186th session

Proposal for Supplement 2 to the 08 series of amendments to UN Regulation No. 9 (Noise of three-wheeled vehicles)

Submitted by the Working Party on Noise and Tyres*

"Figure 1

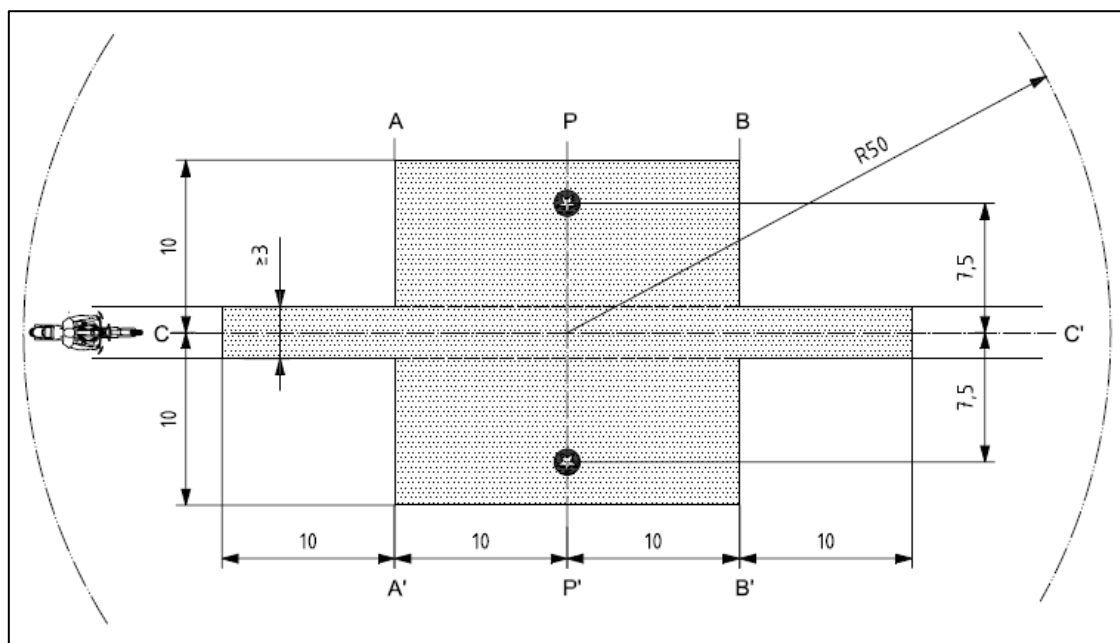
Figure 1, amend to read:

Test track layout with dimensions in meters

Minimum area covered with test road surface, i.e. test area
	Microphone positions (height 1,2m)

Source: ISO 10844:1994, with modifications."
